To: T10 Technical Committee
From: Rob Elliott, HP (elliott@hp.com)
Date: 7 May 2007
Subject: 06-373r3 SAS-2 Zone manager password

Suggested changes

Figure 53 — Physical presence detection extending a ZPSDS example [no change]

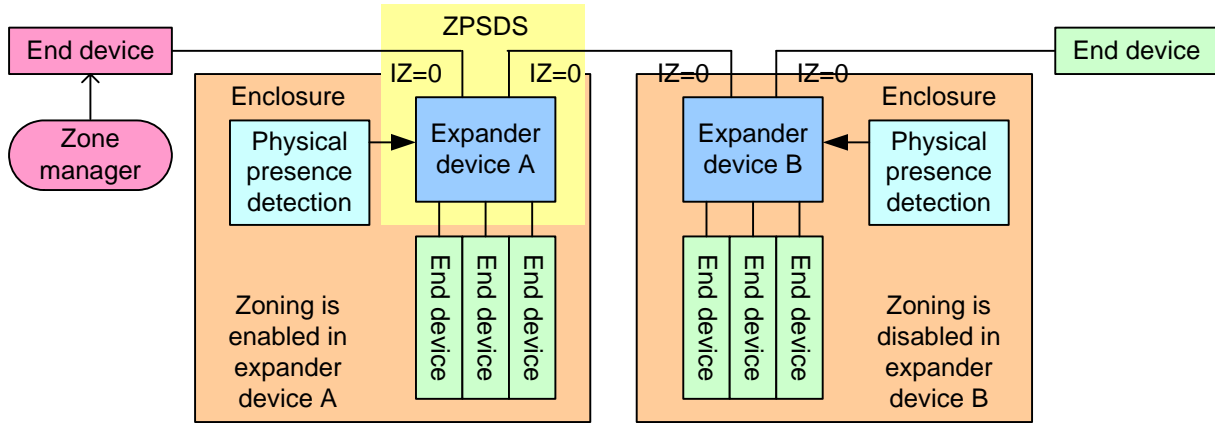
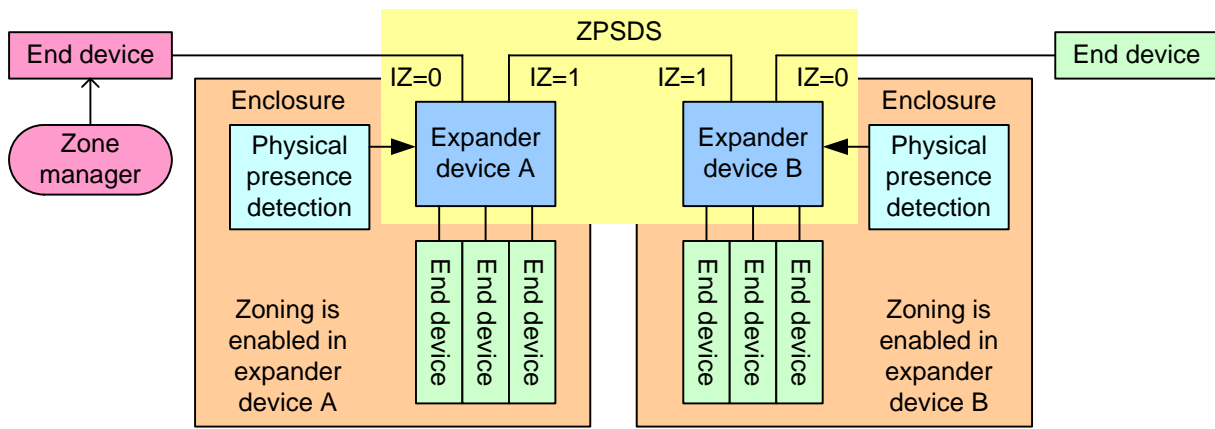
SMP initiator port has access to zone group 2. However, it is not able to enable or configure zoning in expander device B unless physical presence is asserted [or it presents the current zone manager password](#).

Figure 54 — Physical presence detection overtaking a ZPSDS example [no change]

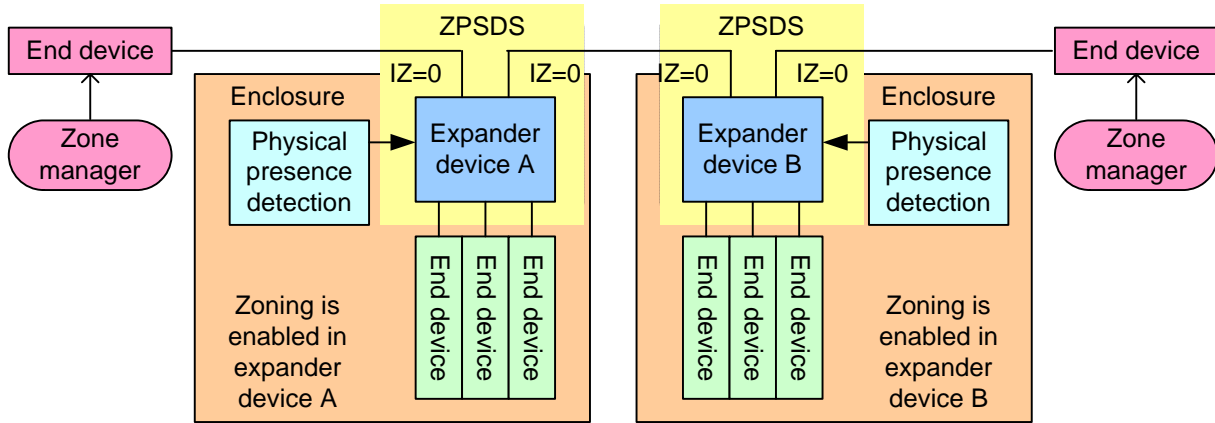
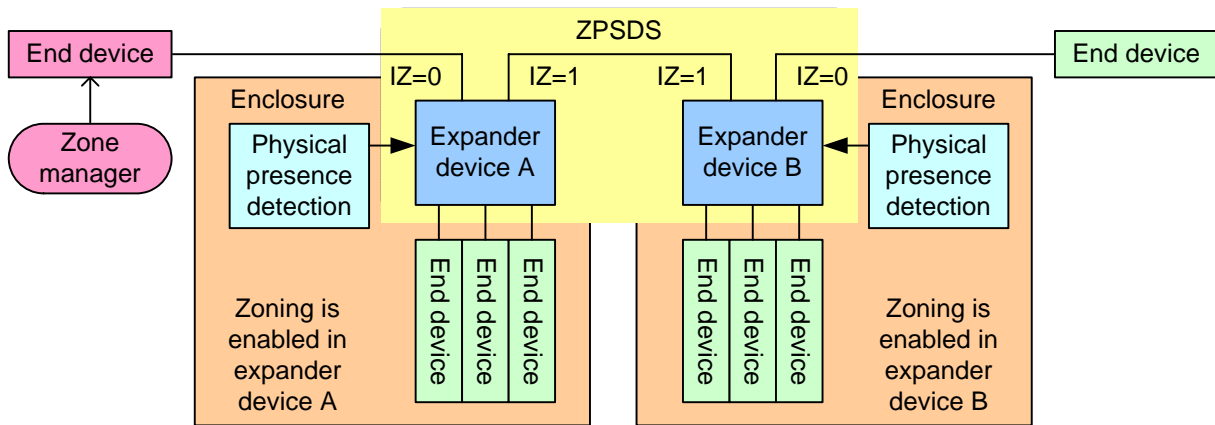
configure zoning in expander device B unless physical presence is asserted [or it presents the current zone manager password](#).
